Edwin I. Hatch Nuclear Plant
Third and Fourth 10-Year Interval Inservice Inspection (ISI) Programs
Submittal to Respond to NRC Request for Additional Information

Enclosure 1 - Responses to NRC Request for Information of September 12, 2005

Enclosure 3
Southern Nuclear Operating Company (SNC)
ISI-ALT-1, Version 3.0
Proposed Alternative in Accordance with 10 CFR 50.55a(a)(3)(i)

FIGURE 1

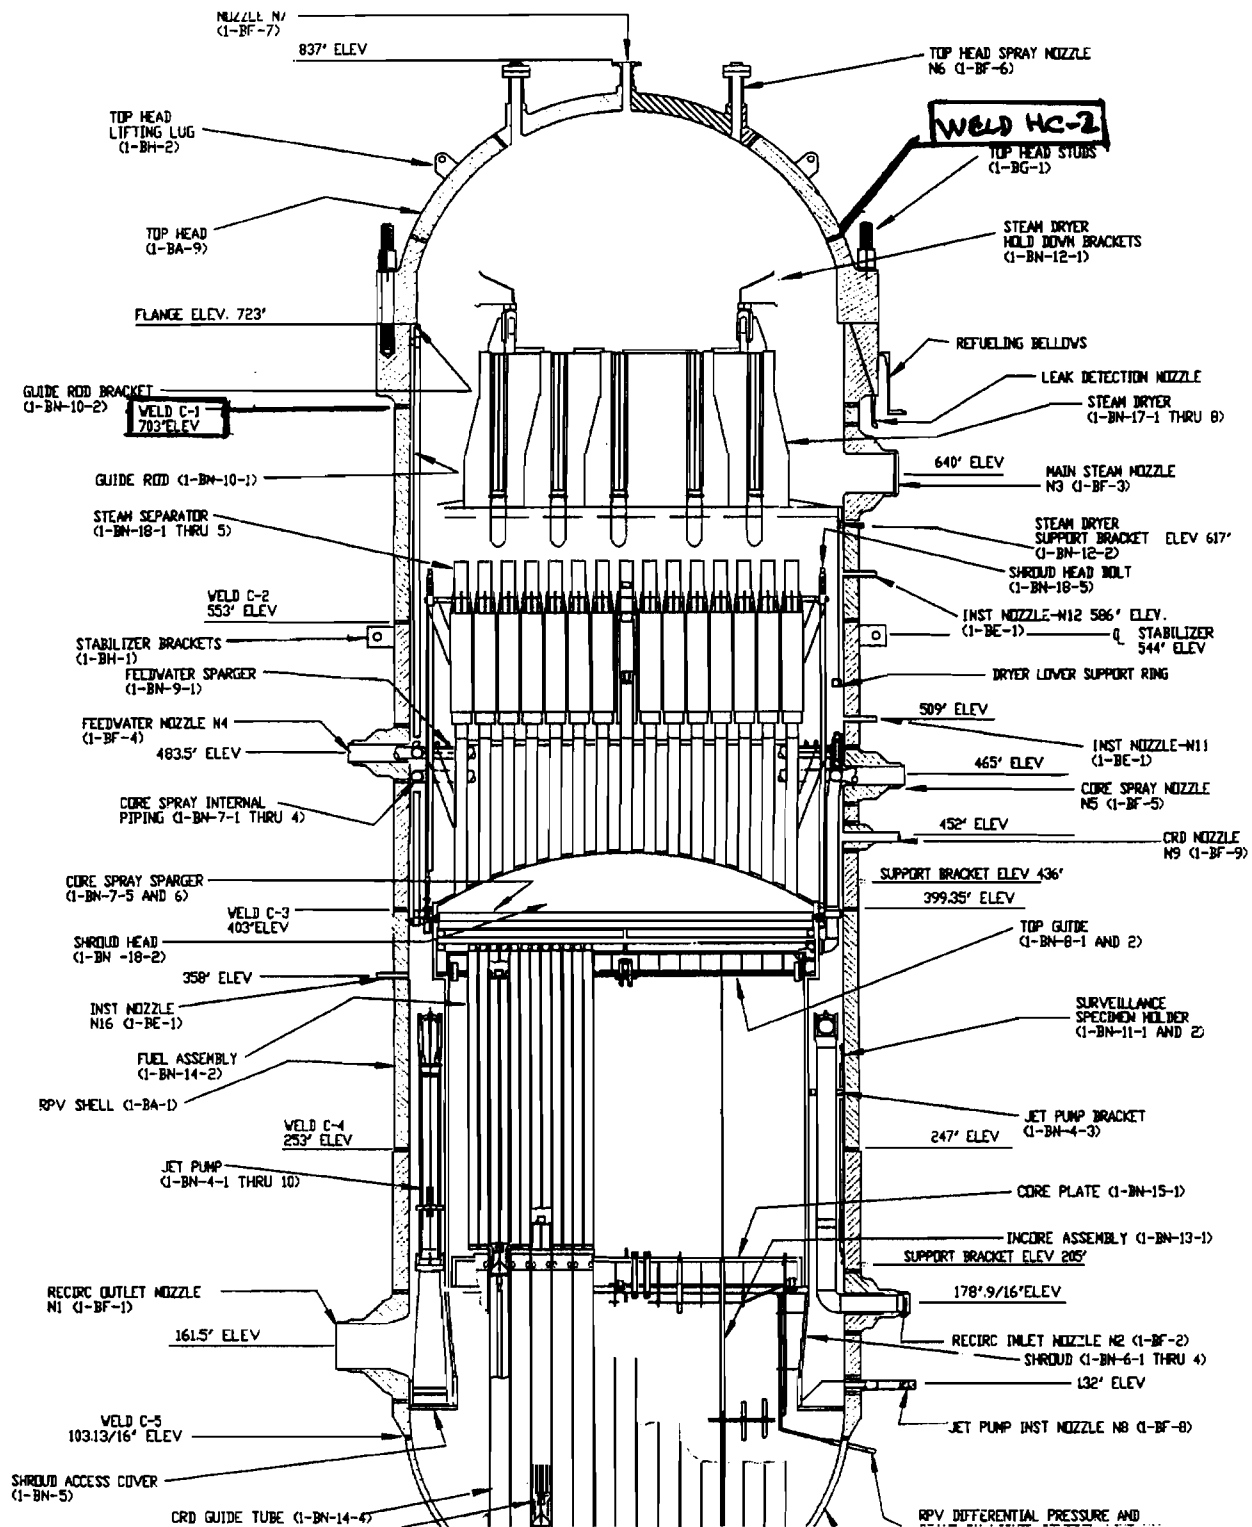
Limitations - This examination will be performed from the outside surface of the vessel. The curvature of the flange limits transducer travel such that scanning can only be performed from the shell side of the weld and as shown in Figure 1 (of ISI-ALT-1) the refueling bellows prevents scanning from the upper portion of the flange surface located above the curvature.

Limitations - As shown in Figure 1 (of ISI-ALT-1), the configuration allows scanning from both the head side and the flange side of the weld; however, the short distance from the weld to the flange limits the amount of scanning that can be performed on the flange side of weld.

In lieu of the Article 4 of Section 5 angle beam examination, SNC proposes to use an angle beam examination that will be performed using examination procedures, personnel, and equipment qualified in accordance with Appendix VIII, Supplements 4 and 6, as amended by the conditions set forth in 10 CFR 50.55a. Examination of each weld is described below: (See Figure 1)

FIGURE 2

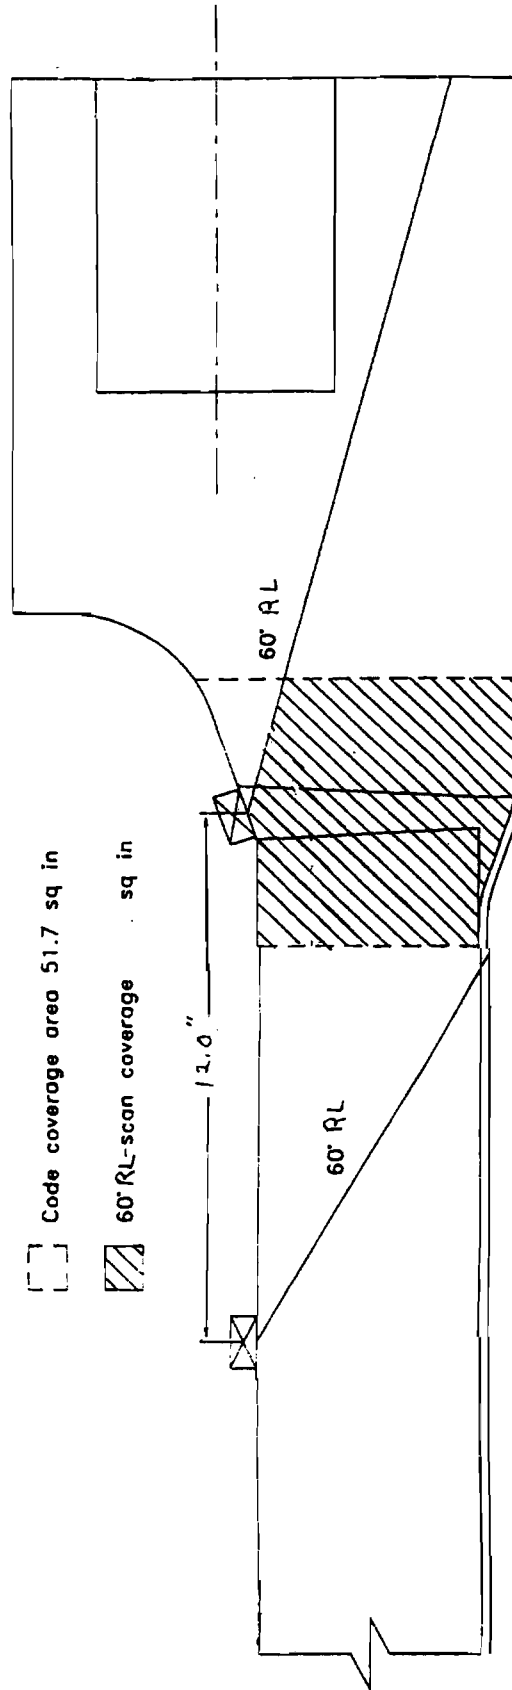
Examination Requirements - SNC proposes to use a single side angle beam examination that will be performed using examination procedures, personnel, and equipment qualified through the PDI process in accordance with Appendix VIII, Supplements 4 and 6. Projected coverage for flaws

located parallel to weld is shown in Figure 2 of ISI-ALT-1. Since the examination will be from a single side, the requirements of 10 CFR 50.55a(b)(2)(xvi)(A) apply. Therefore, examinations will be conducted with equipment, procedures, and personnel that have demonstrated proficiency with single side examinations. (To demonstrate equivalency to two sided examinations, the demonstration must be performed to the requirements of Appendix VIII as modified by this paragraph and 10 CFR 50.55a(b)(2)(xv) (B) through (G), on specimens containing flaws with non-optimum sound energy reflecting characteristics or flaws similar to those in the vessel being examined). Scanning will be performed as follows:

The Section XI required examination volume will be scanned for flaws from the outside of the vessel using a 60-degree refracted longitudinal wave; however, the curvature of the flange surface above the weld will limit transducer travel such that examinations can only be performed from the shell side. Additionally, the refueling bellows prevents examinations from being performed from the vertical portion of the flange surface located directly above the curvature. The projected single side coverage for flaws located parallel to the weld is shown in Figure 2.

FIGURE 3

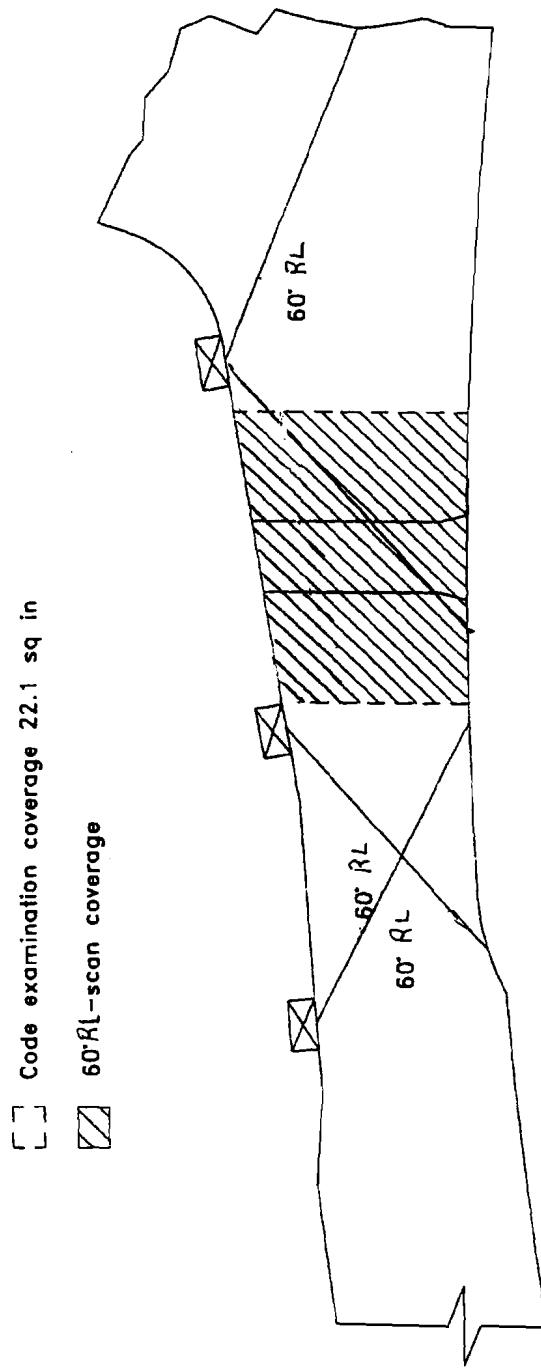
Examination Requirements – The head is not clad; therefore, SNC proposes to use an angle beam examination that will be performed using examination procedures, personnel, and equipment qualified through the PDI process in accordance with Appendix VIII, Supplement 6 as modified by 10 CFR 50.55a(b)(2)(xv)(D), 10 CFR 50.55a(b)(2)(xv)(E), and other applicable paragraphs. Scanning will be performed in four orthogonal directions to the extent practical. Projected coverage for flaws located parallel to weld is shown in Figure 3 of ISI-ALT-1.

3. In the basis section of the submittal, the licensee makes a statement that the vessel flange examination will be eliminated because it does not improve flaw detection. Please provide supporting detail for the statement. Identify the scanning requirements that will be followed. Provide sketches of the examination volume showing the proposed scanning directions and transducer angles.

The Section XI required examination volume will be scanned for flaws using a 60-degree refracted longitudinal wave. Examinations will be performed from both the head and flange side of the weld; however, the short distance from the weld to the flange limits the examination on the flange side of weld. Scanning will be performed in four orthogonal directions to the extent practical with the projected coverage for flaws located parallel to the weld shown in Figure 3. This weld is not clad; therefore, the examination of the Section XI required volume will be performed using procedures, personnel, and equipment qualified through the PDI process in accordance with Appendix VIII, Supplement 6, as modified by 10 CFR 50.55a(b)(2)(xv)(D), 10 CFR 50.55a(b)(2)(xv)(E), and other applicable paragraphs.
